DSB SERVICE BULLETIN No. 10-2013 Ver.2

Title: Marine - Liferafts : Replace all OTS-65 PRVs after 10 year life

This Service Bulletin Number 10-2013 Version 2 has been technically approved by Survitec Group Design Authority.

FIGURE 02

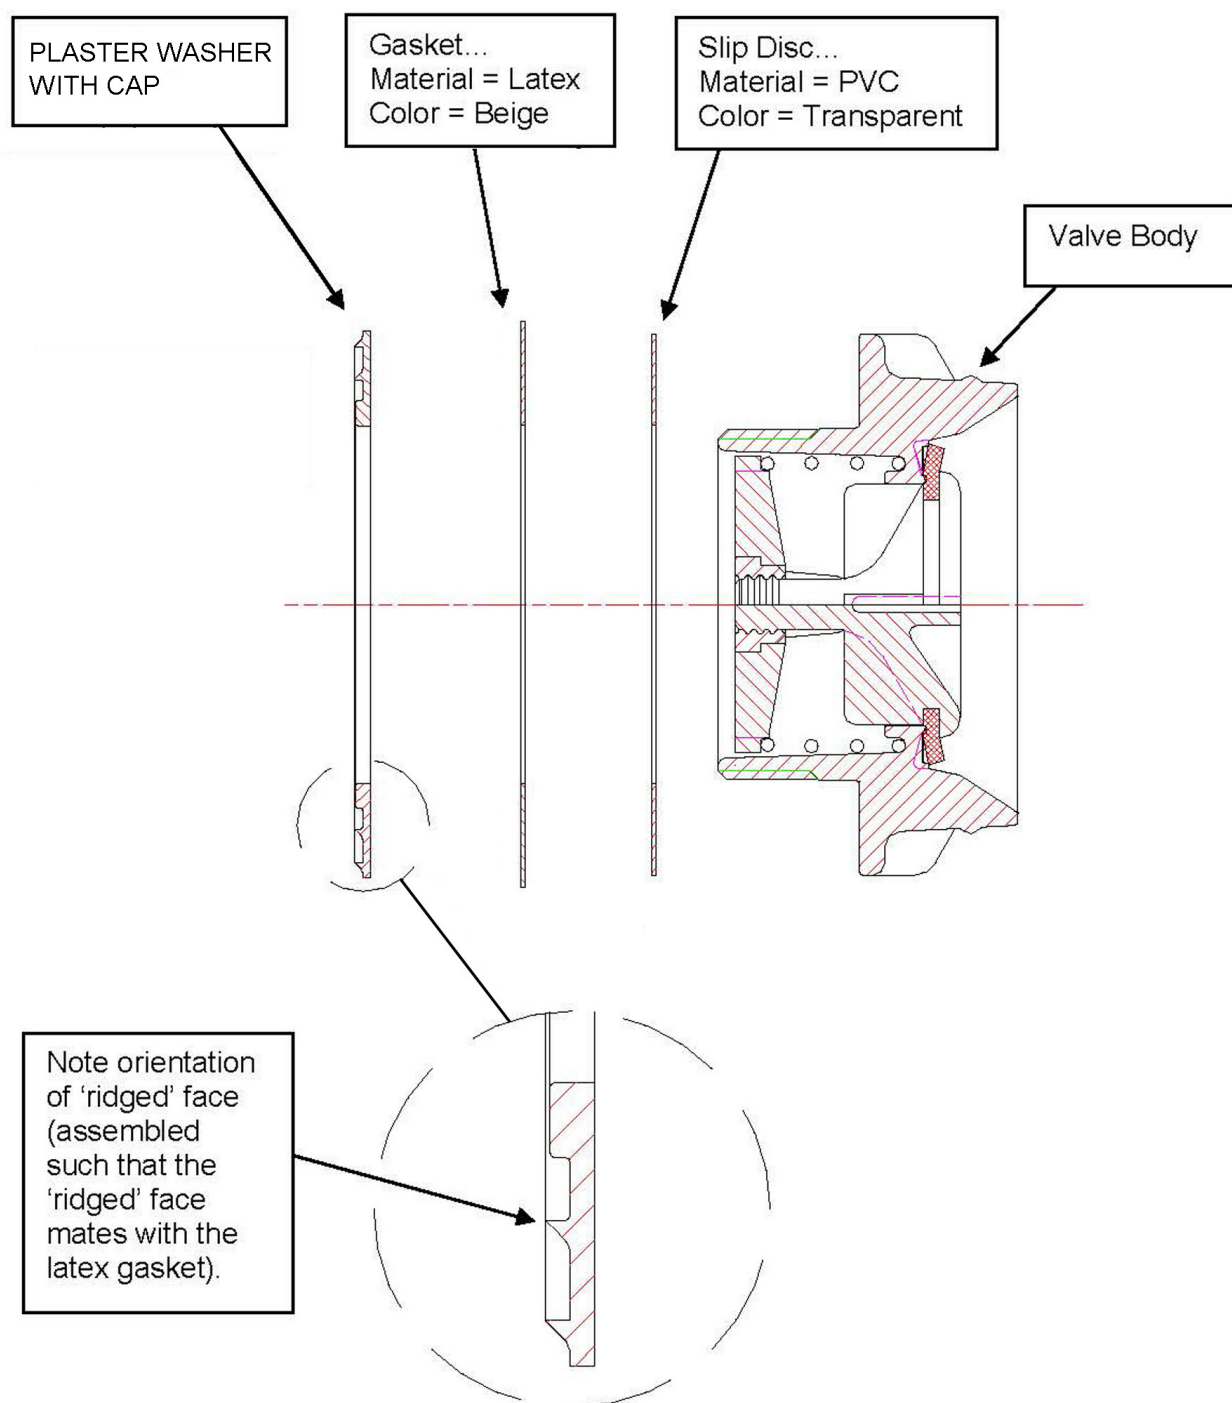
- 6.2.1 Loosely assemble the 'outboard' components of the new PRV see (FIGURE 02). Set them aside temporarily.
- 6.2.2 Install the new nut through the hole in the doubler from which the old PRV was removed.
- 6.2.3 Make sure that the inboard and outboard surfaces of the PRV doubler, that will match with the new PRV assembly, are clean and dry. If necessary wipe clean using toluene solvent on a clean lint-free cloth. Allow any solvent to evaporate before continuing.
- 6.2.4 Hold the nut in place through the buoyancy fabric. Slowly hand-tighten the pre-assembled "outboard" components of the new PRV onto the nut, clamping the buoyancy fabric doubler in the process (FIGURE 03).
Tighten the outboard components slowly to make sure that the gasket remains flat as it tightens against the PRV doubler.

FIGURE 03

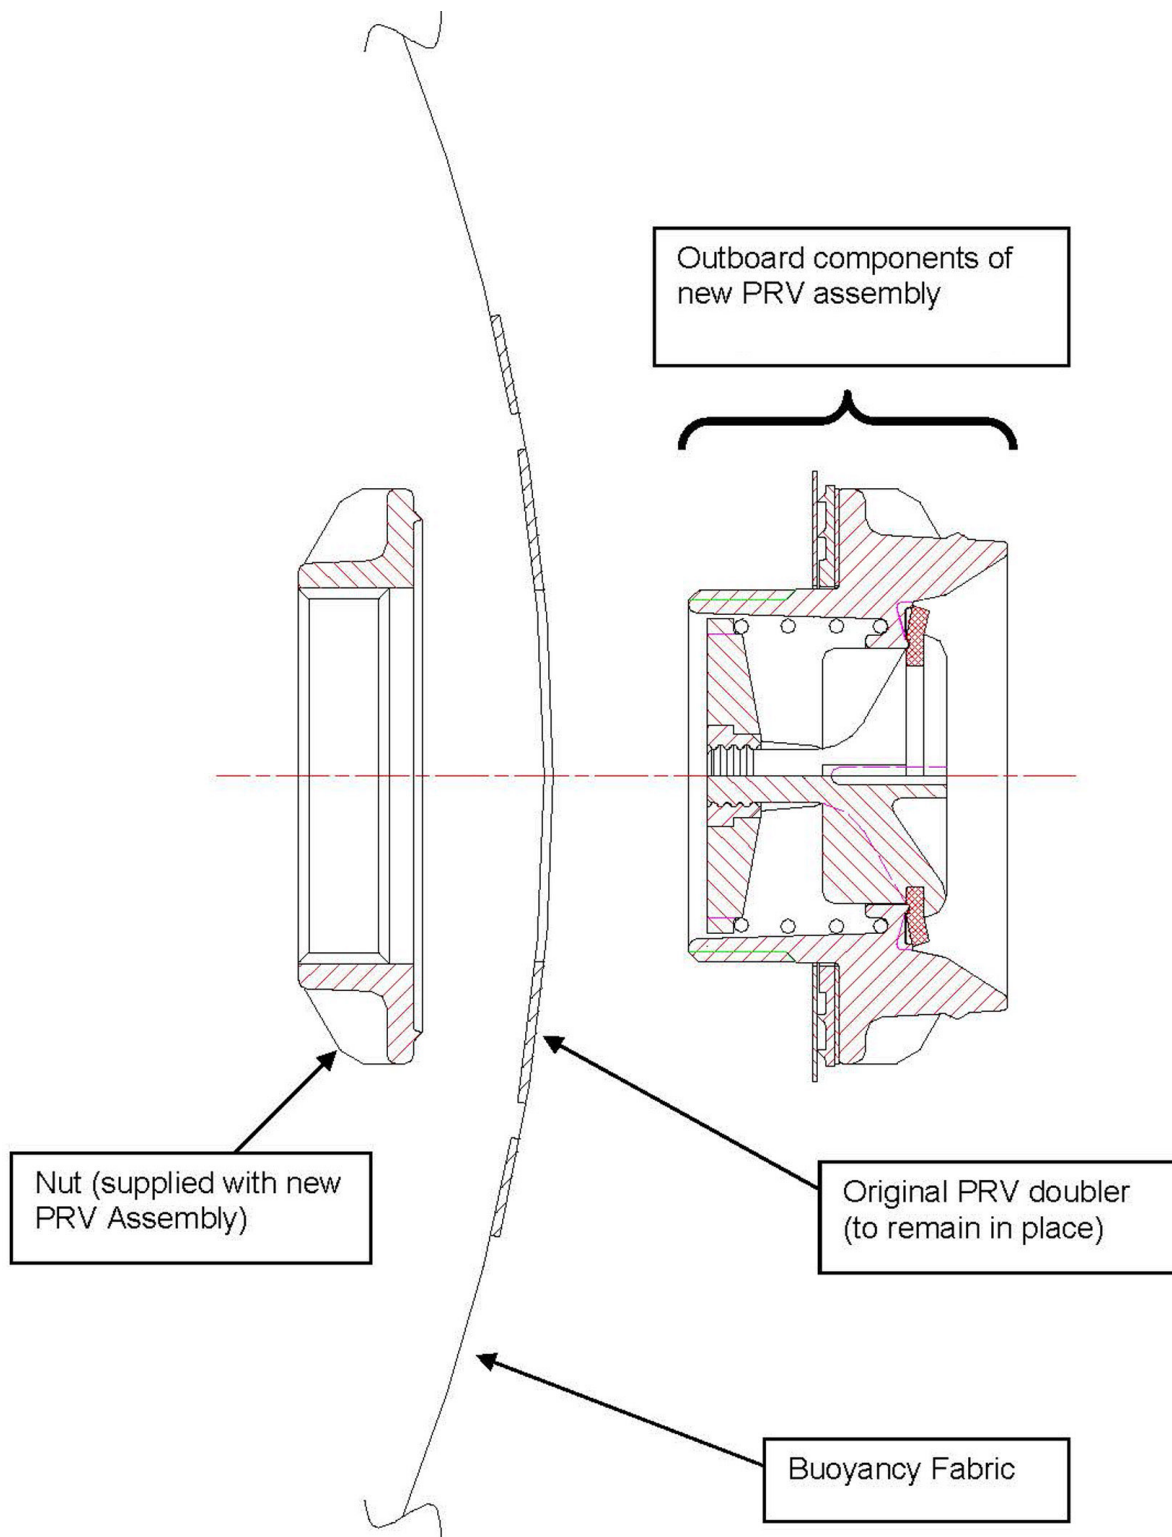
- 6.2.5 Set the torque wrench – calibrated to (27 Nm / 20 lbf/ft is recommended) 30 Nm / 22 lbf/ft **maximum**.

- 6.2.6 Slowly inflate the chamber to which the PRV is fitted. As the buoyancy is taking shape and the pressure is starting to rise, begin tightening the PRV body.
